PUBLIC HEARING July 14, 2020

Subject: ZAB Appeal: 1533 Beverly Place, Administrative Use Permit #ZP2018-0153

Conduct a public hearing and, upon conclusion, adopt a Resolution affirming the decision of the Zoning Adjustments Board to approve Administrative Use Permit #ZP2018-0153 to enlarge an existing 1,212 square-foot, one-story single-family dwelling with a non-conforming front setback on a 4,200 square-foot lot by constructing a 1,035 square-foot addition, including a new second story that would increase the average building height from 16 feet 3½ inches to 23 feet 7½ inches, and adding a fifth bedroom, and dismiss the appeal.

**Photo 1:** Story Poles with Design Revision Indicated, As Seen from the Kitchen Table of 1710 Sonoma Avenue. Photo by Amy Di Costanzo.

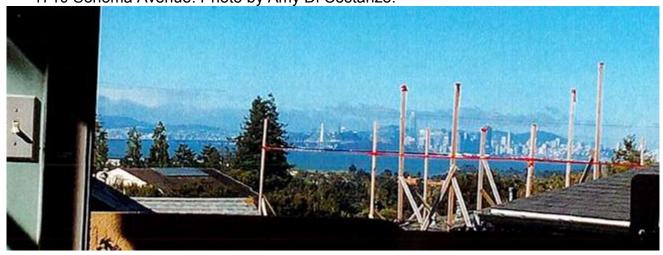
The appellant submitted photos of the view from their kitchen toward San Francisco in their appeal letter. Photo 1 below was taken from a seated position at the table at the back of the kitchen, with the doors to the deck open. The original story poles are in the photo, and the height of the proposed building after the plans were revised is indicated by the red horizontal line.

Staff Response: The BMC defines a view corridor as a "significant view of the Berkeley Hills, San Francisco Bay, Mt. Tamalpais, or a significant landmark such as the Campanile, Golden Gate Bridge, and Alcatraz Island or any other significant vista that substantially enhances the value and enjoyment of real property." The photos submitted by the appellant show the story poles at the height of the original design for the addition, with a string at a lower height to reflect the revisions to the project. The string between the story poles indicates how the applicants lowered the proposed height and replaced the sloped roof with a flat roof. With the revised addition, the Bay Bridge and San Francisco Skyline would still be visible from the kitchen of 1710 Sonoma Avenue. Although the view of the water below the Bay Bridge and San Francisco Skyline would

Staff finds the addition to be reasonable. With the proposed addition the residence at 1533 Beverly would be two stories and 2,247 square feet; the average size of a two-story dwelling on this block of Beverly Place and the block of Sonoma Avenue to the rear is 2,018 sq. ft. As the appeal does not provide evidence that the Zoning Officer's approval was made in error, staff recommends the ZAB dismiss this appeal point.

FINISH FLOOR AS SHOWN ON EISENMANN
ARCHITECTURE "DESIGN REVISION 2" DRAWING
4/A3.1 DATED 06.27.19

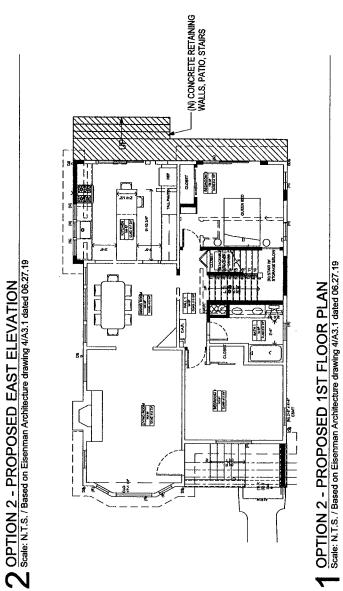
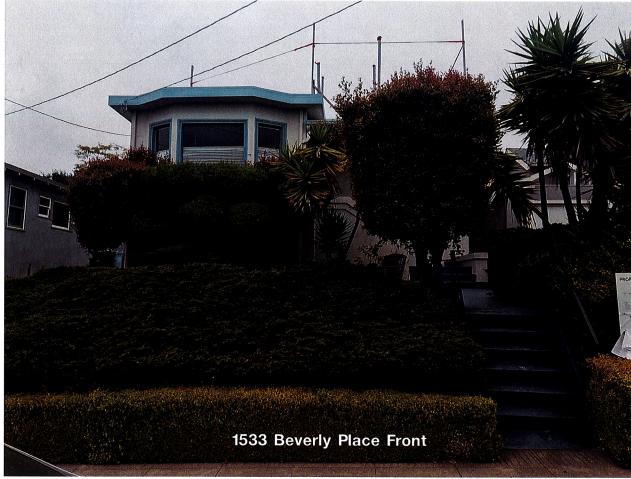
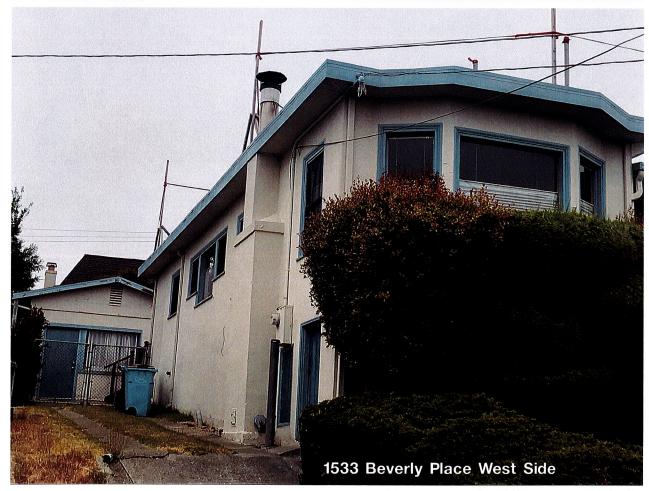
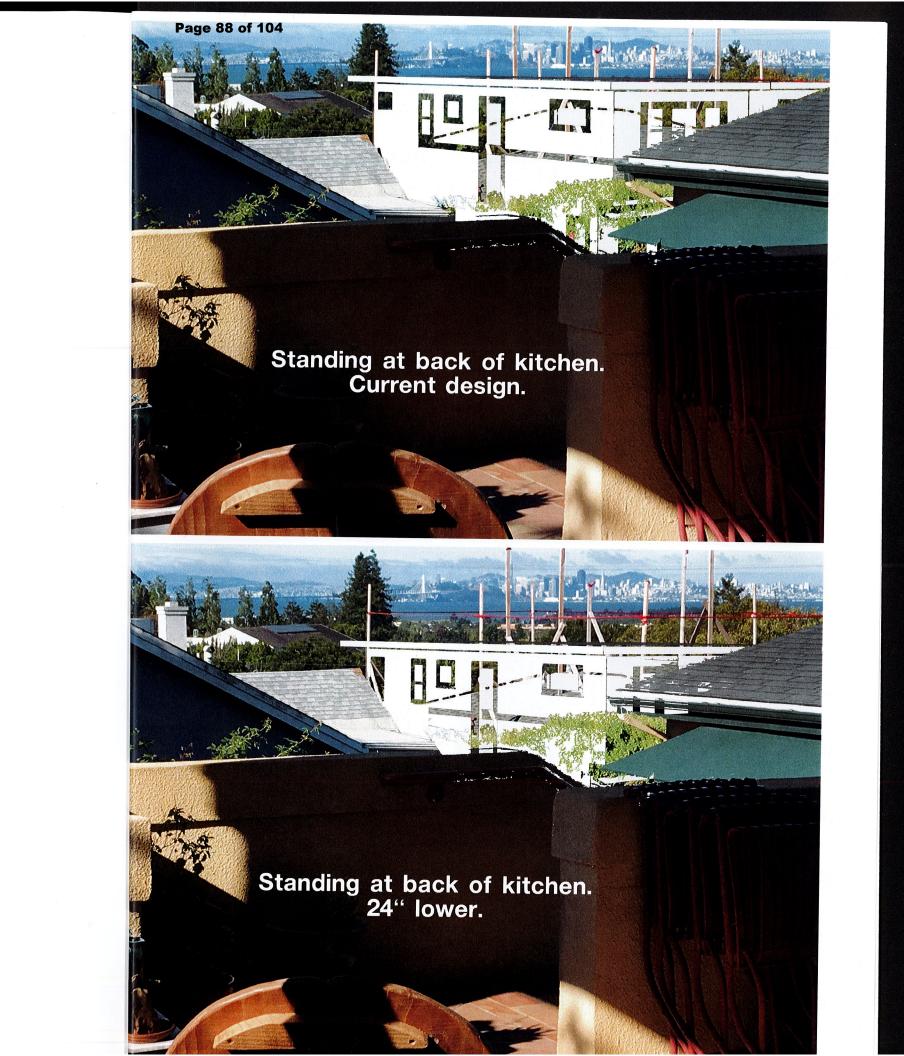
PROPOSED LOWERED FINISH FLOOR-

PROPOSED— LOWERED ROOF

ROOF AS SHOWN ON EISENMANN-ARCHITECTURE "DESIGN REVISION 2" DRAWING 4/A3.1 DATED 06.27.19
